SUBJECT: ADDENDUM NO. 2  
INVITATION FOR BID J19340  
2<sup>ND</sup> FLOOR TRANSACTION COUNTER IMPROVEMENTS  
KAUIKEAUOLI HALE, DISTRICT COURT OF THE 1<sup>ST</sup> CIRCUIT  
PROJECT IDENTIFIER: OMB 19-05-A

**THE JUDICIARY, STATE OF HAWAII**  
**IFB J19340**  
**KAUIKEAUOLI HALE**  
**2<sup>ND</sup> FLOOR COUNTER IMPROVEMENTS**

**QUESTIONS AND ANSWERS**

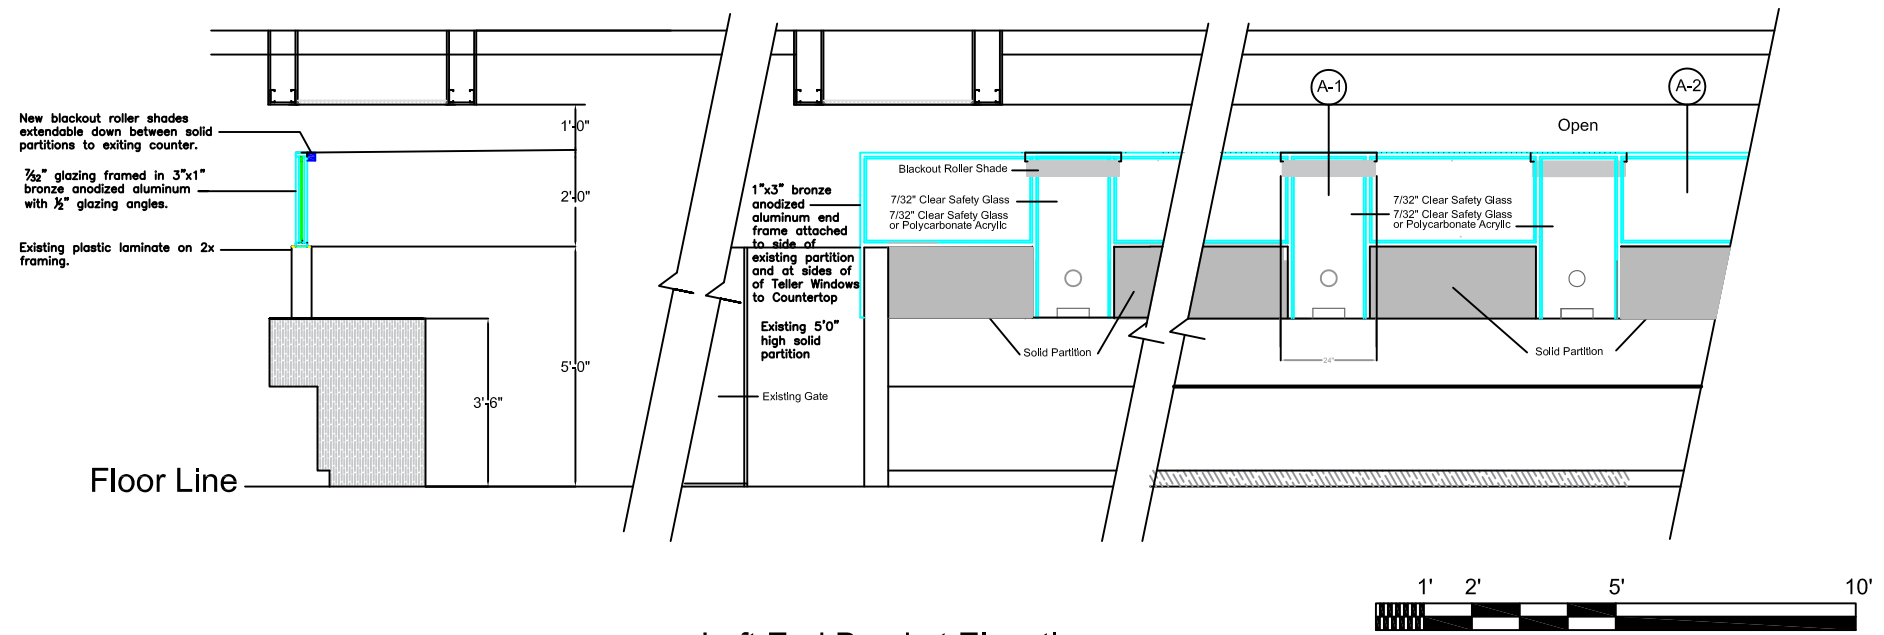
**Question #1:**

**“Do we need to have both a “B” and a “C-22” license to bid on this project?**

**No, you do not have to have both a “B” and a “C-22” license to bid on this project. The “Requirements and Specifications,” Section 00110, Notice to Bidders, page 3 should have read “To be eligible to submit a Bid, the bidder must possess valid State of Hawaii Contractor’s license classification “B” and/or “C-22”**

**A “C-22” license is the only license required for this project. A “B” license holder can bid on this project as long as they possess a “C-22” sub license or list a subcontractor possessing this license and comply with the requirements of the “Requirements and Specifications”, Section 00210 Instructions to Bidders, Sub-section 1.05 – F, paragraphs 1 – 6.**
